# UNITED STATES PATENT AND TRADEMARK OFFICE

10/756,886

<b>Office Action Summary</b>	<b>Application No.</b> 10/756,886	<b>Applicant(s)</b> LEUNG ET AL.	
	<b>Examiner</b> James R. Harvey	<b>Art Unit</b> 2833

## ***DETAILED ACTION***

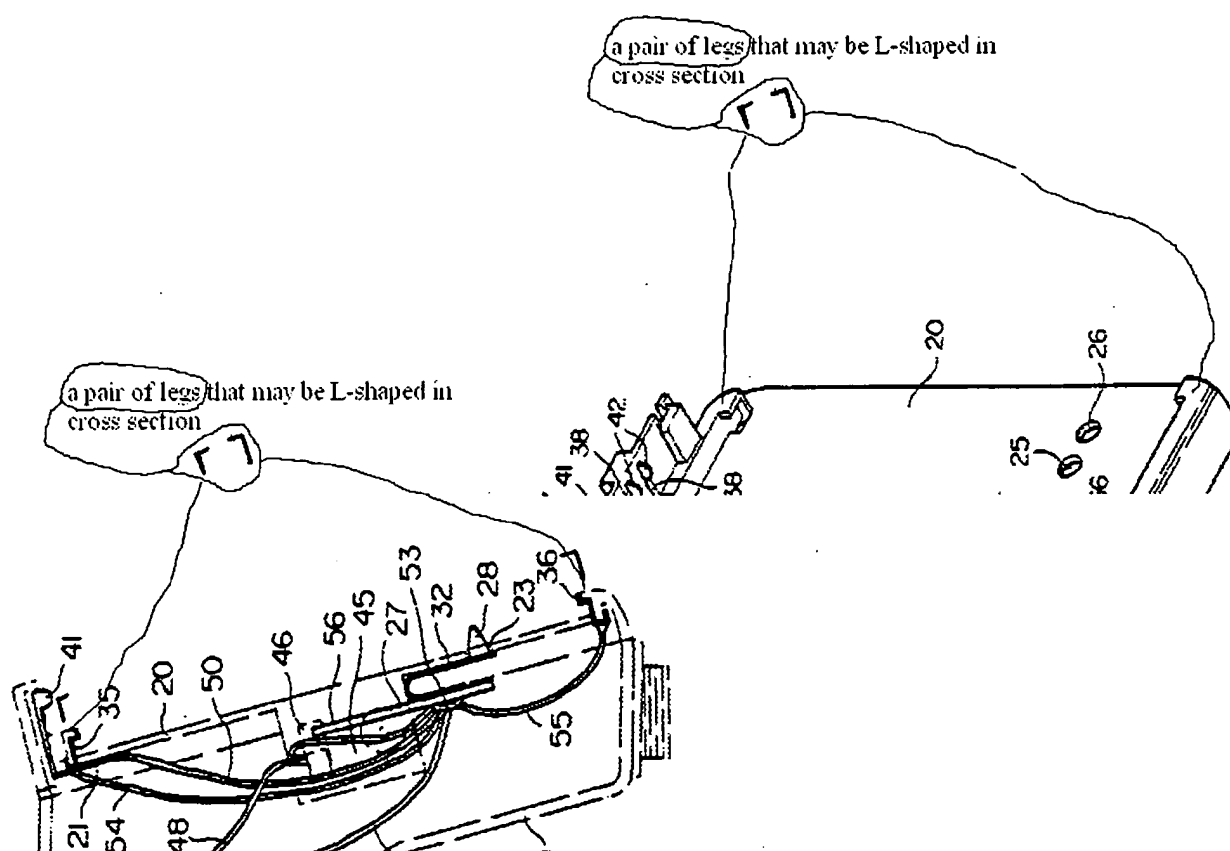
-- In reference to Claim(s) 4, Applicant's specification ( page 7, line 7 ) describes the holding strap as a pair of legs that may be L- shaped in cross section. Huang shows ( figure 4 and (cover sheet) ) the member 15 has a holding strap that is a pair of legs that are L-shaped in cross-section (see examiner's figure) configured to retain the member 15 adjacent the end of the battery.

-- In reference to Claim(s) 14, Applicant's specification ( page 7, line 7 ) describes the holding strap as a pair of legs that may be L- shaped in cross section. Huang shows ( figure 4 and (cover sheet) ) the member 15 has a holding strap (see examiner's figure) configured to retain the member 15 adjacent the end of the battery.
